## **Proposal for Supplement 1 to the 03 series of amendments to UN Regulation No. 127 (Pedestrian Safety)**

### **Submitted by the experts from France and OICA \***

# I. Proposal

Figure 13: Upper corner definition with template

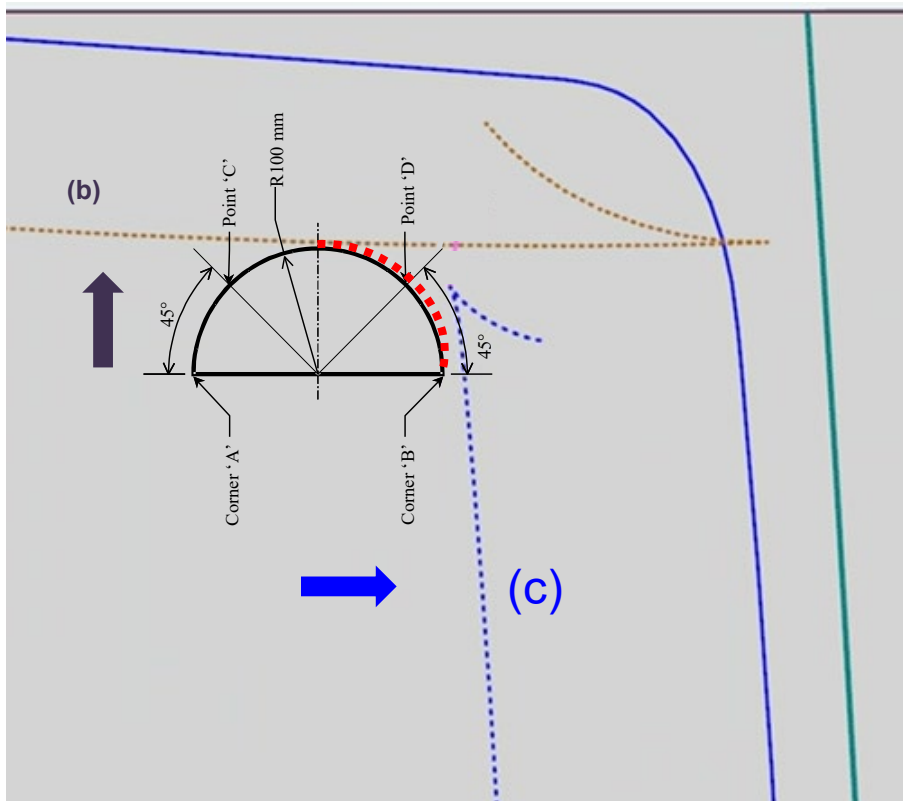
Where the lines defined in (b) and (c) do not intersect, they should be extended and/or modified using the semi-circular template defined in 2.8., as shown in Figure 13.

The template should be placed on the vehicle with corners “A” and “B” turned to the front of the vehicle, and Points “C” and “D” to the rear and with line AB parallel to the median transversal plane of the vehicle. The template should be slid progressively rearwards transversally until the arc of the template makes first contact with the line defined in (b).

Ensuring line AB remains parallel to the median transversal plane and first contact of the template with line defined in (b) is maintained, the template should be slid progressively transversally rearwards until the arc of the template makes first contact with the line defined in (c). Throughout the process, the template should be curved to follow, as closely as possible, the outer contour of the vehicle's windscreen, without wrinkling or folding of the template. Then the contour of windscreen test area is extended and/or modified to follow the circumferential arc of the template to meet the line defined in (c), as shown in Figure 13.

If the template cannot make simultaneous contact with lines defined in (b) and (c), then additional templates should be used where the radii are increased progressively in increments of 20 mm, until simultaneous contact with lines defined in (b) and (c) are achieved.

**Figure 14:**

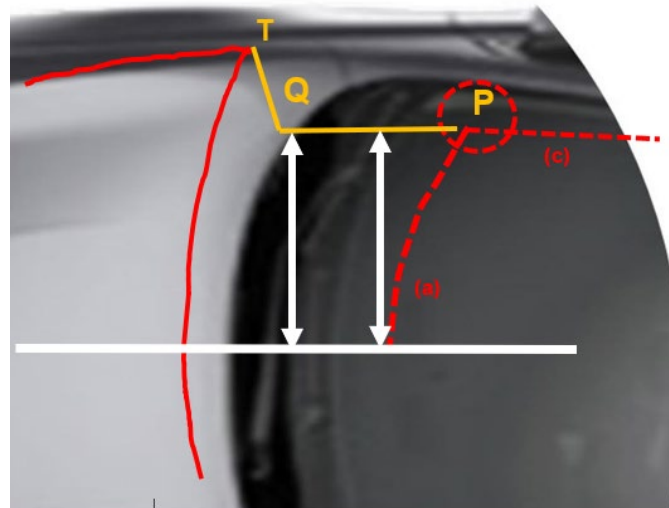
**In order to generate the lateral boundary of the cowl monitoring area (see Figure 14), at each side:**

- the "P corner point" will be projected forward to the rear edge of the bonnet top and create Q point;
  - the Q point will be connected to the "T point" (rear corner of the bonnet top test area);
- using a flexible tape held tautly from point P to Q and on the outer surface of the vehicle from point Q to T.
